Staff Report

Re: Detached Accessory Dwelling Unit – Conditional Use - PLNPCM2021-00899

PROPERTY ADDRESS: 1167 E. Sherman Avenue

The property owner, Jean Arment is requesting conditional use approval for a 15-foot tall, 420-square-foot detached accessory dwelling unit (ADU) that will be located along the northeast property line of the property at 1167 Sherman Avenue.

Proposed elevations

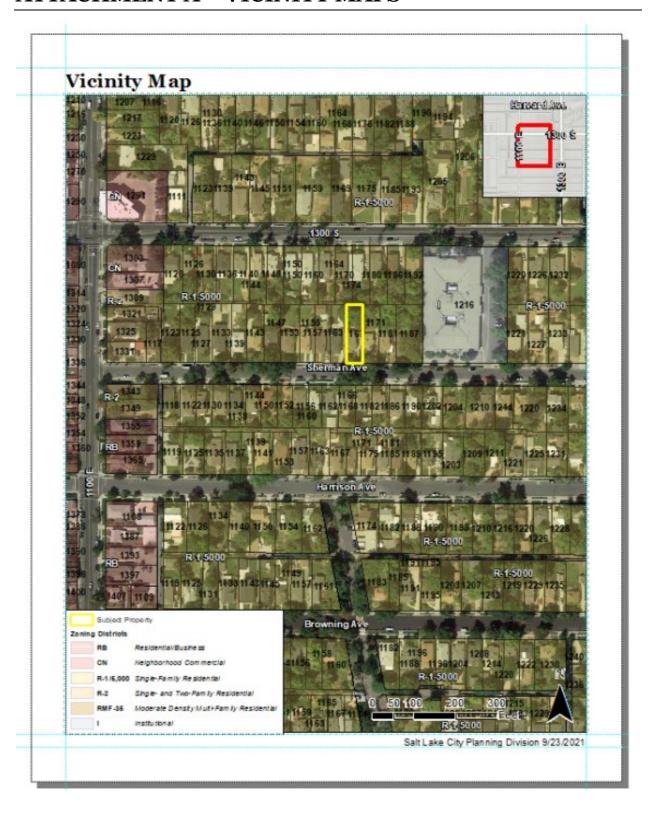
The proposed ADU has a gabled roof and will not exceed the maximum height of 17 feet. The primary exterior building material for the east facing wall will be a hardie board siding (cement, fiber-glass matrix that is non-combustible) and for the other sides, the applicant plans to use cedar siding and may paint it similar to the color of the main dwellings brick color. The proposed windows are casement style, similar to several on the primary residence. The entrance to the proposed ADU faces the west.
